ADDENDUM NO. 1

CRANDALL ISD – PERFORMING ARTS CENTER ADDITION TO CRANDALL HIGH SCHOOL

AUGUST 26, 2024

1E BRICK VENEER - OUTSIDE CORNER
A9.2 SCALE: 3" = 1'-0"

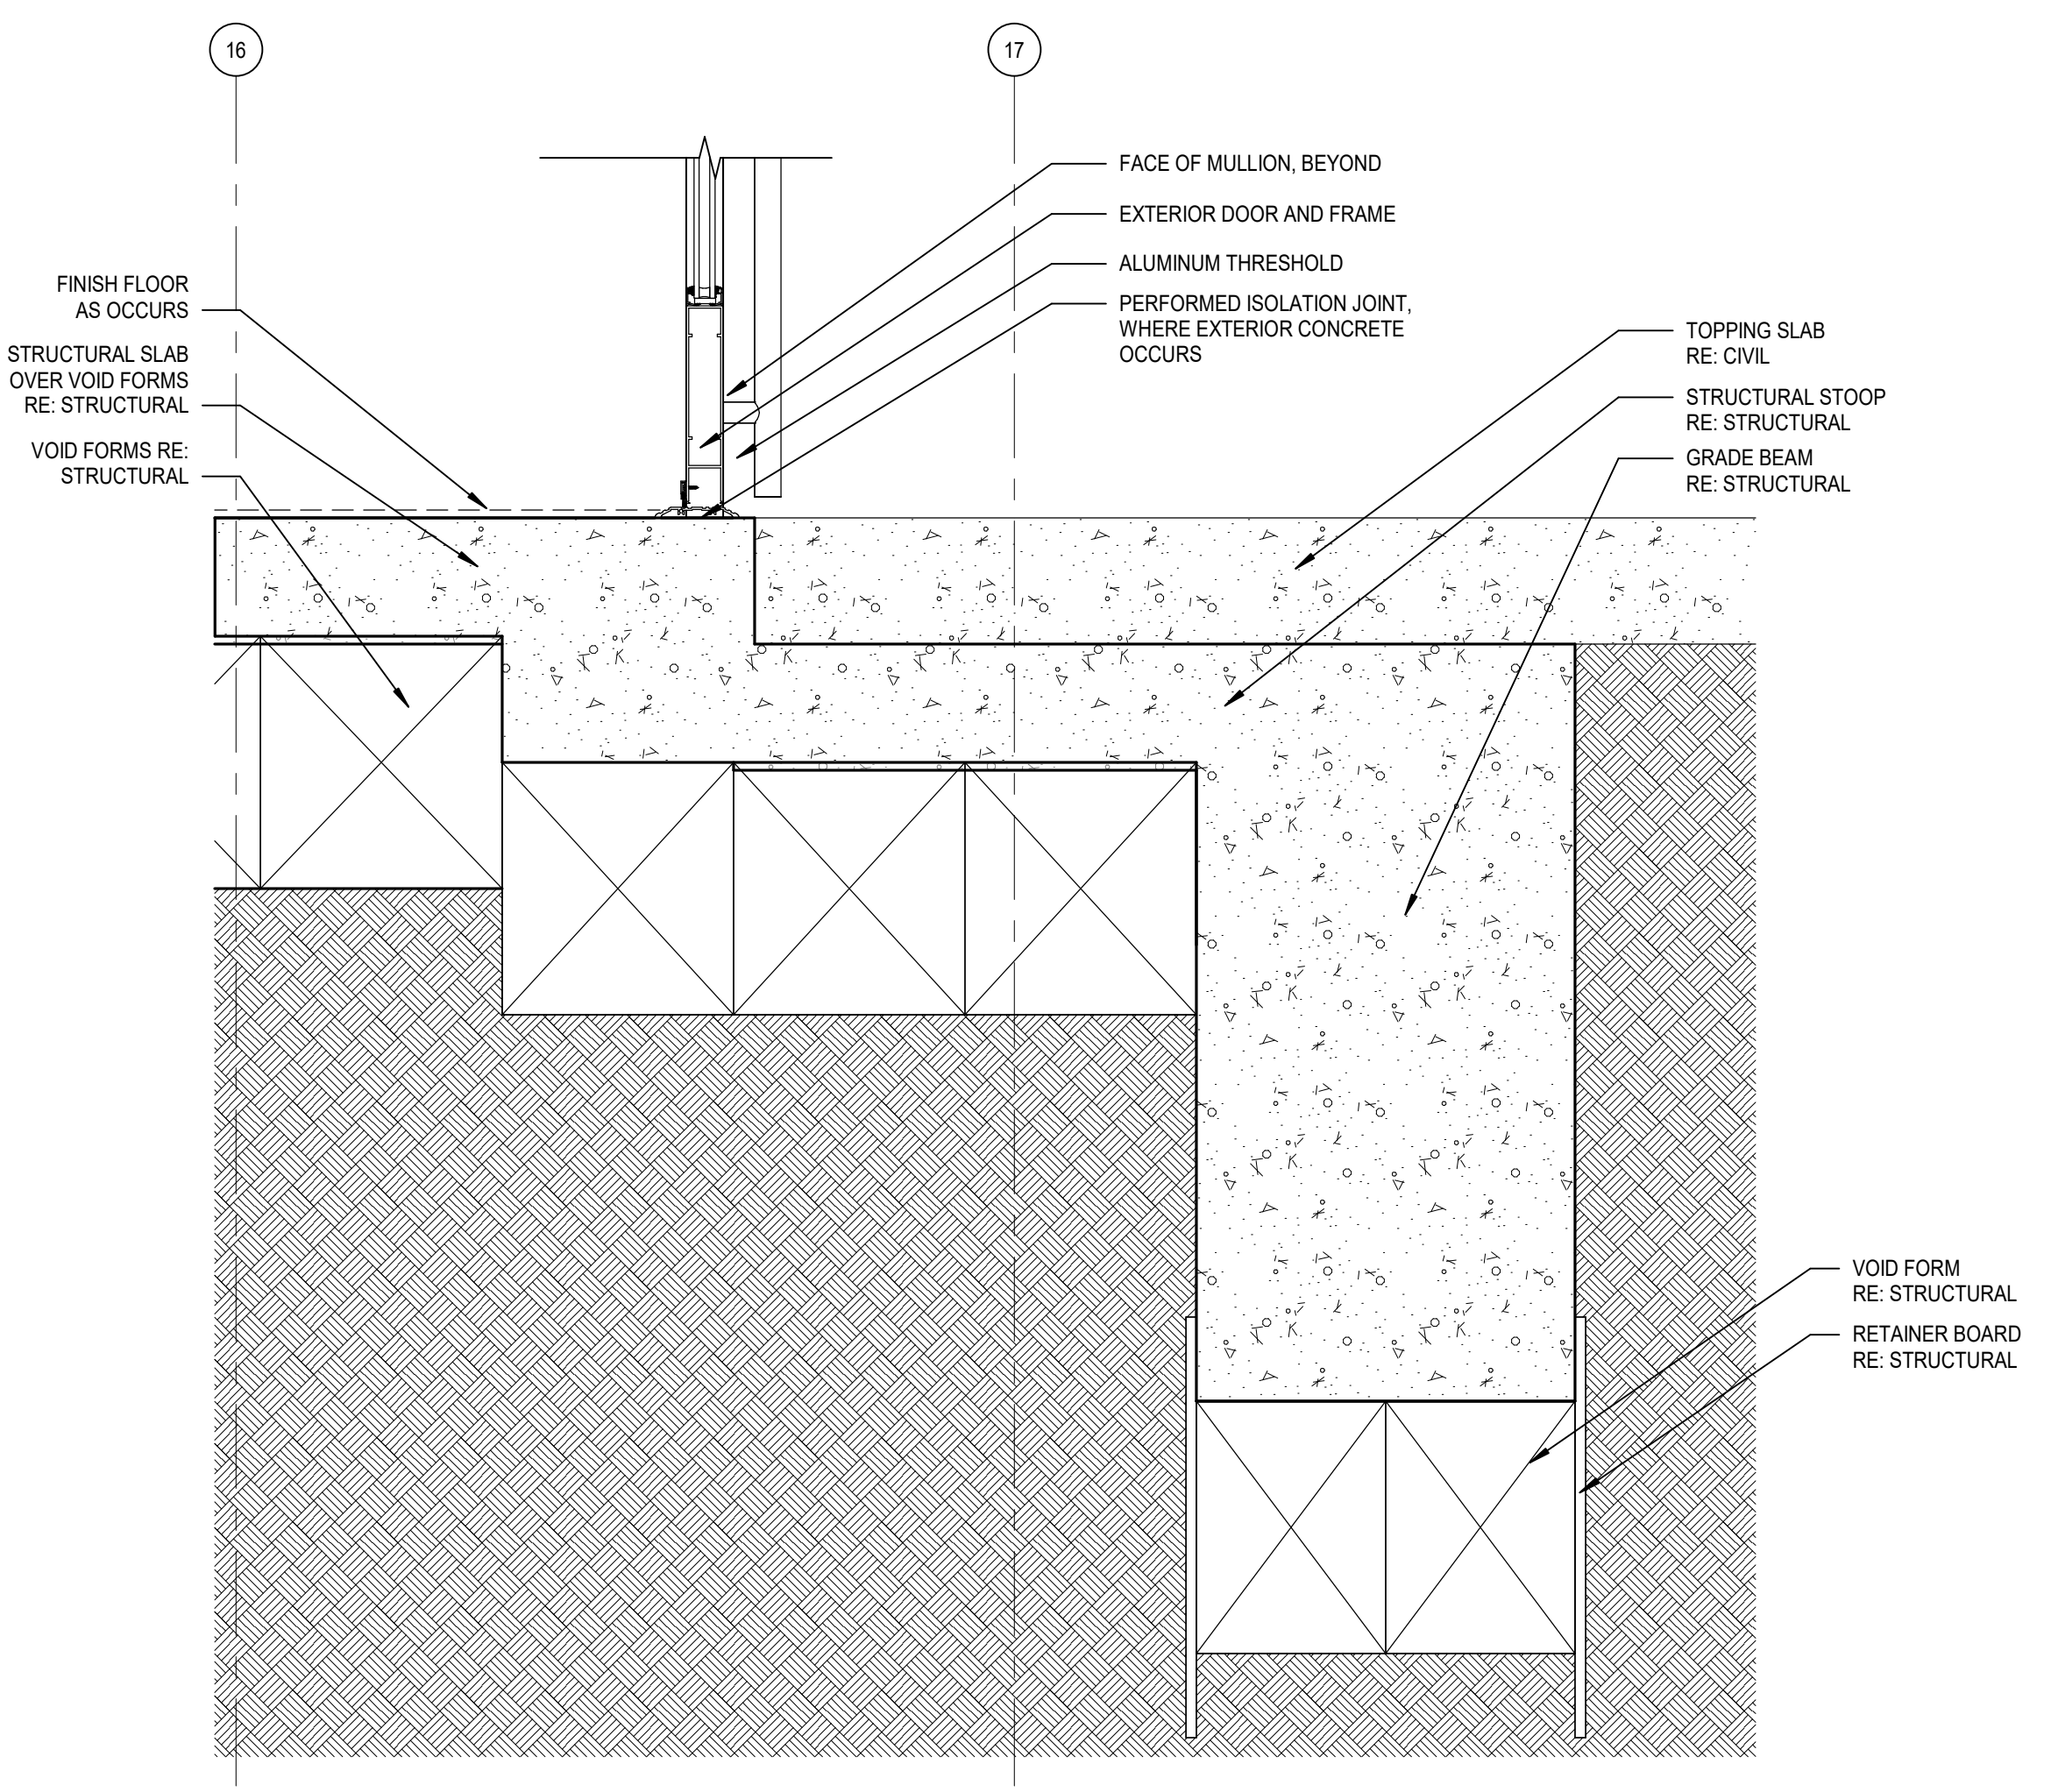
- ITEM 29. A9.0 – EXTERIOR ASSEMBLIES – Detail 1A has been revised as indicated on the re-issued sheet.
- ITEM 30. A9.2 – EXTERIOR DETAILS – Details 1E, 2D, 5B, and 5C have been revised as indicated on the re-issued sheet.

3A SECTION AT DOCK LEVEL
S3.5 SCALE: 3/4" = 1'-0"

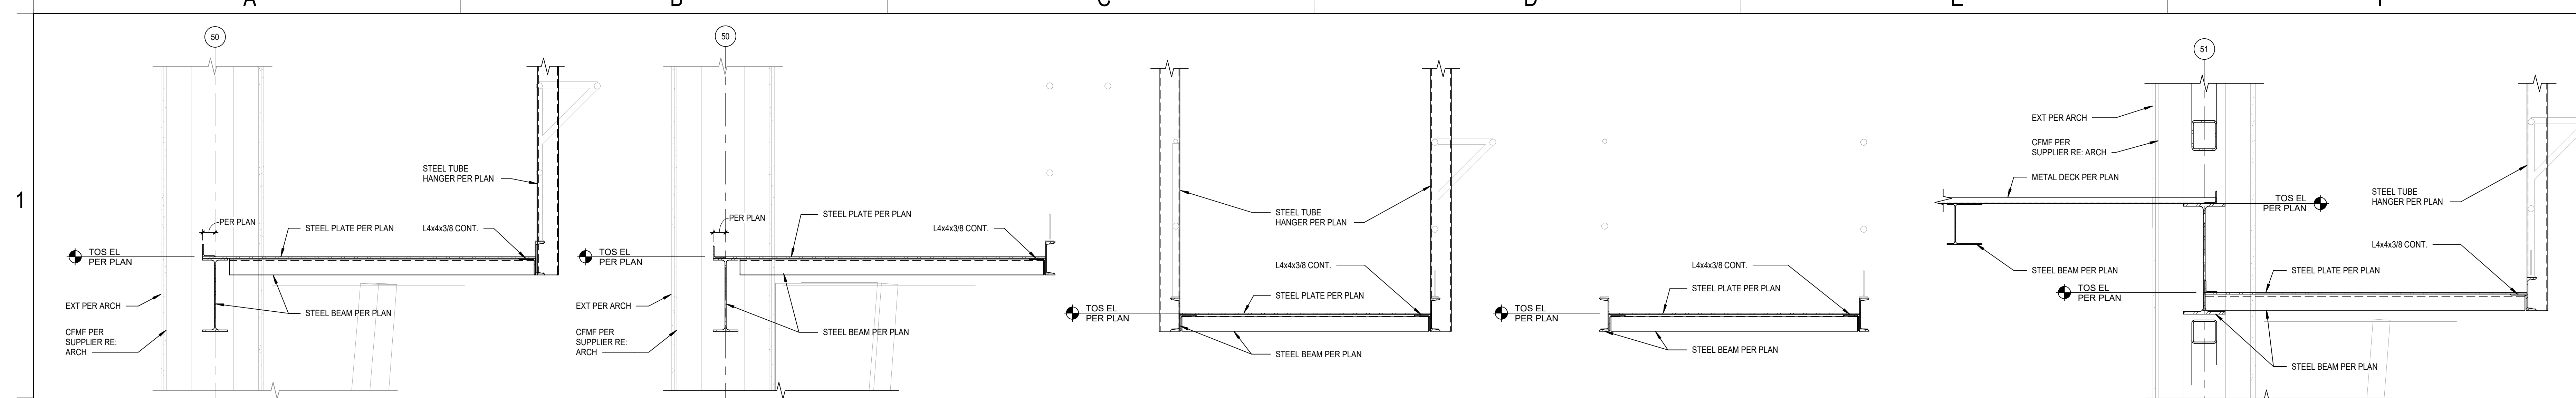
- ITEM 40. S3.5 – STRUCTURAL DETAILS – Detail 3A has been revised to include continuous angles to protect corners of the dock leveler as indicated on the re-issued sheet.

39-23712-00
OVERALL UNDERGROUND PLUMBING PLAN

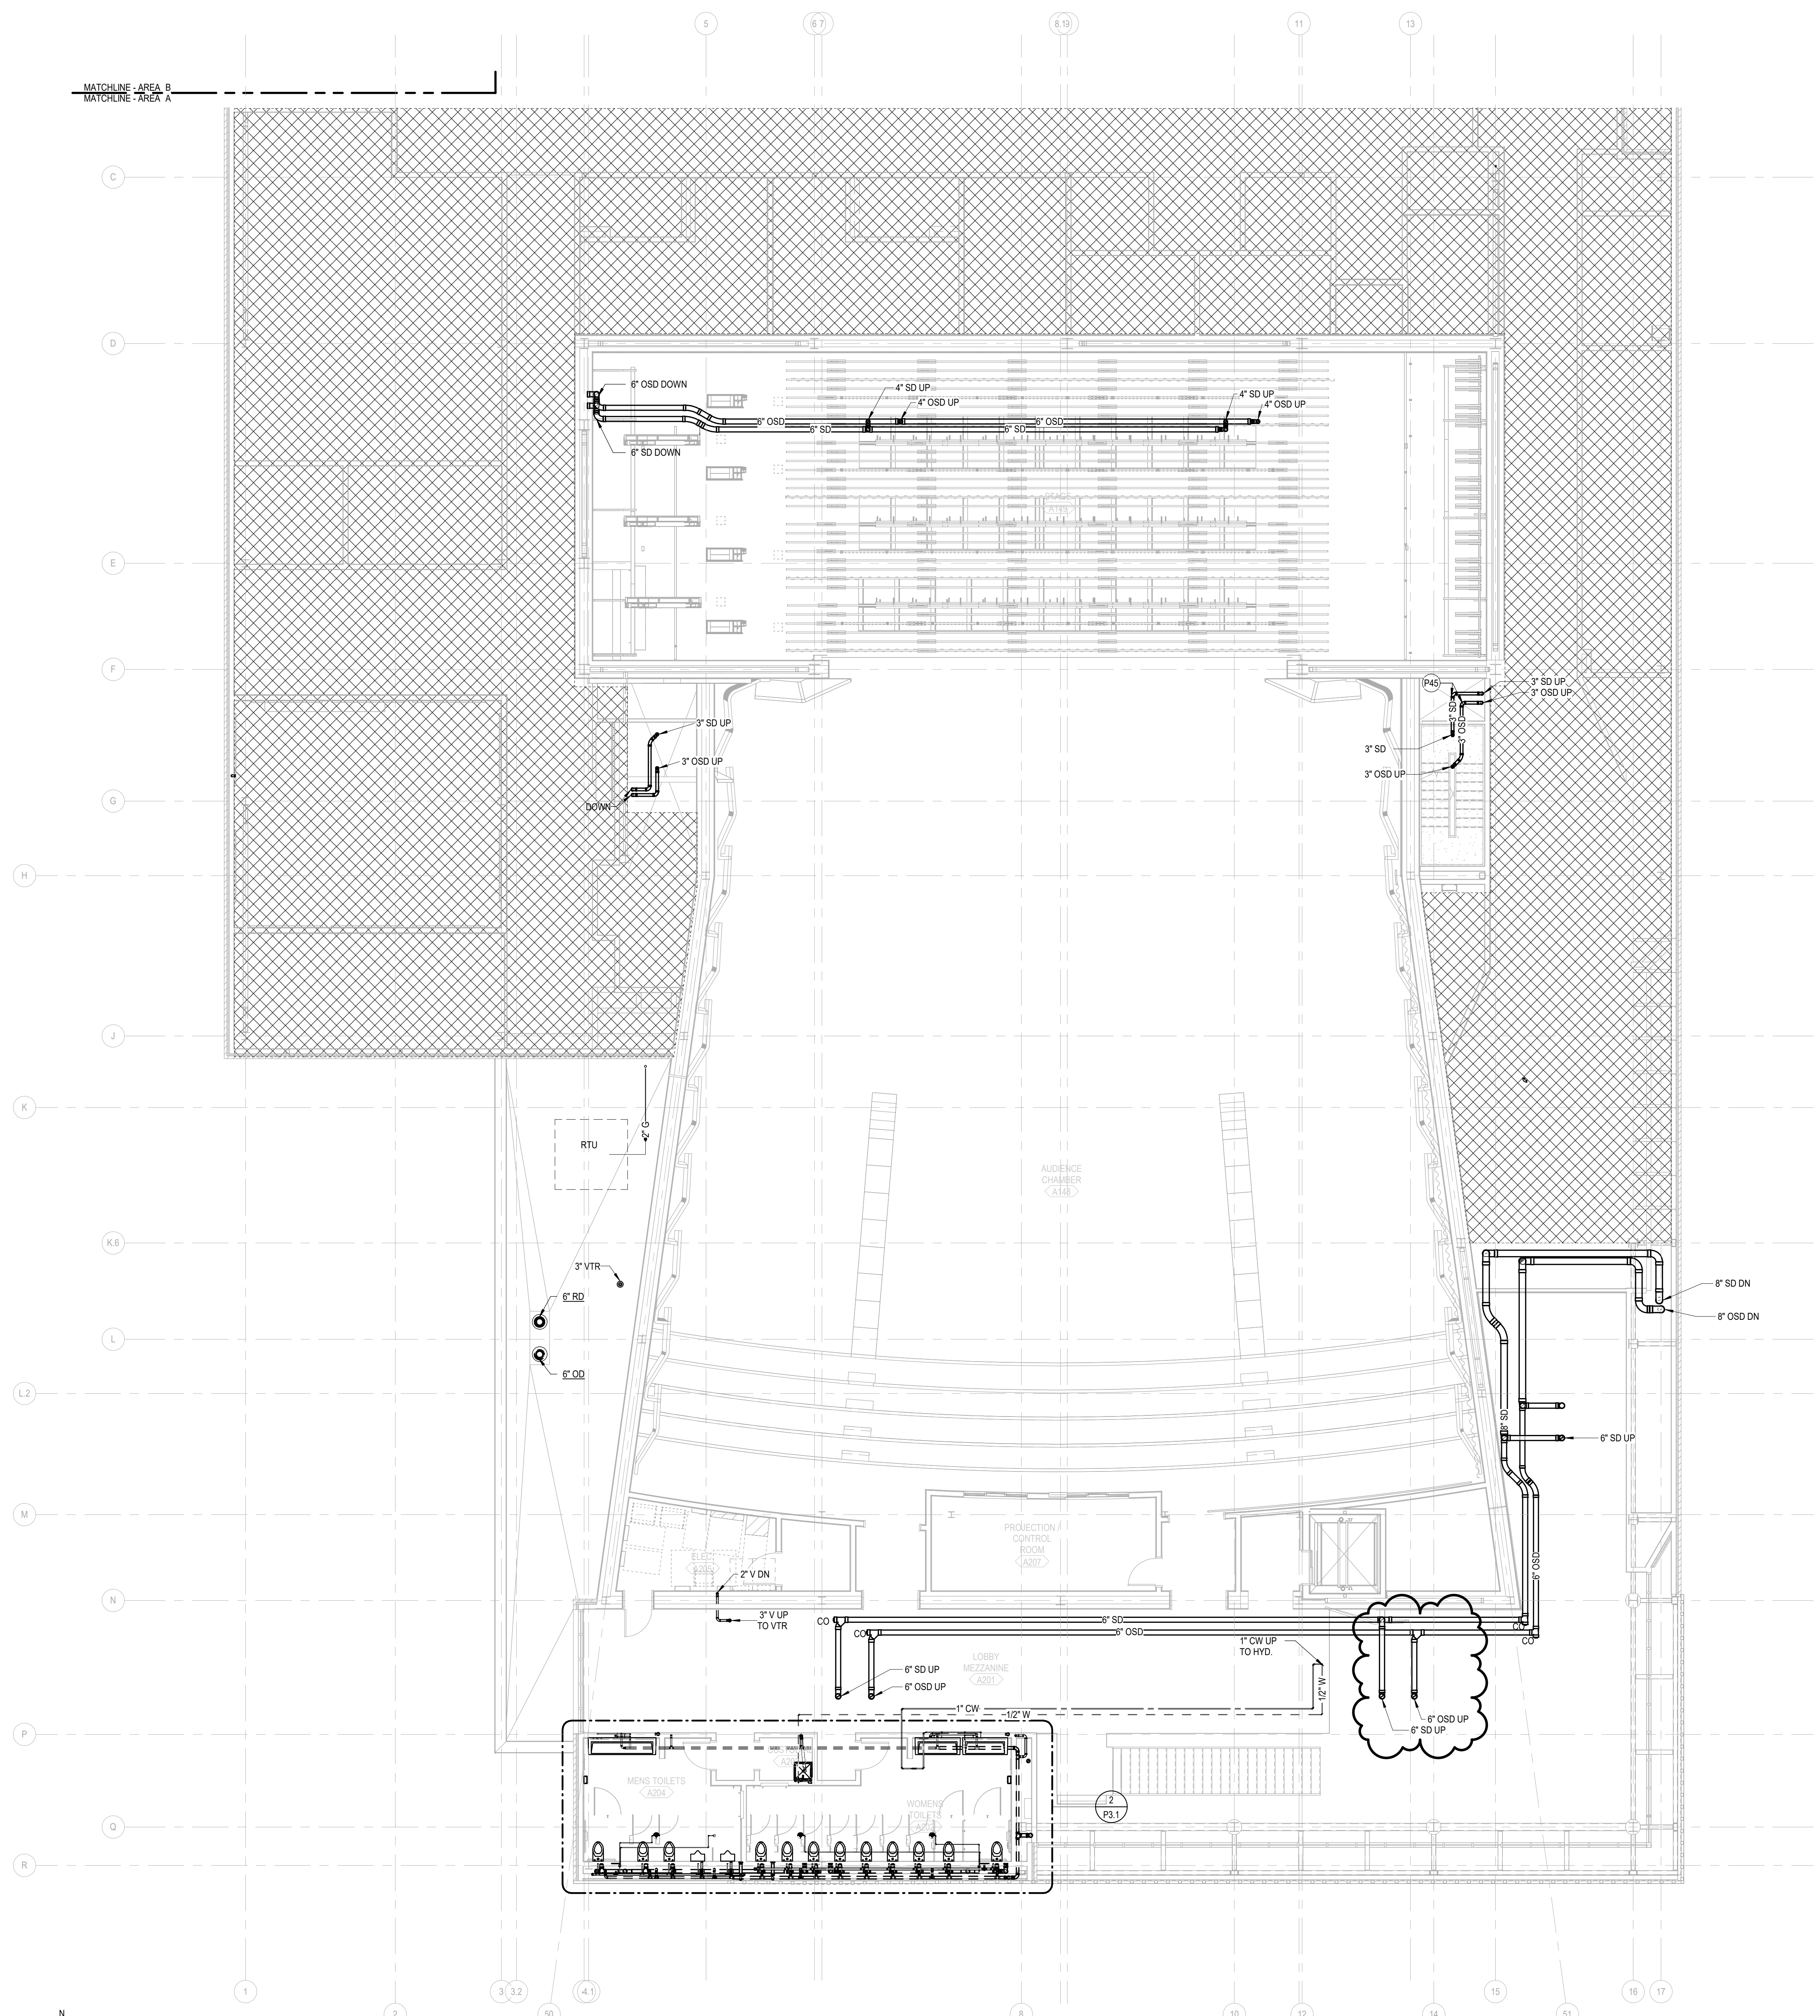
- ITEM 43. P0.1 – PLUMBING GENERAL NOTES & SYMBOLS – has been revised to include plumbing void form note as indicated on the re-issued sheet.
- ITEM 44. P2.1 – OVERALL UNDERGROUND PLUMBING PLAN – has been revised to include FDC and additional priming ups as indicated on the re-issued sheet.
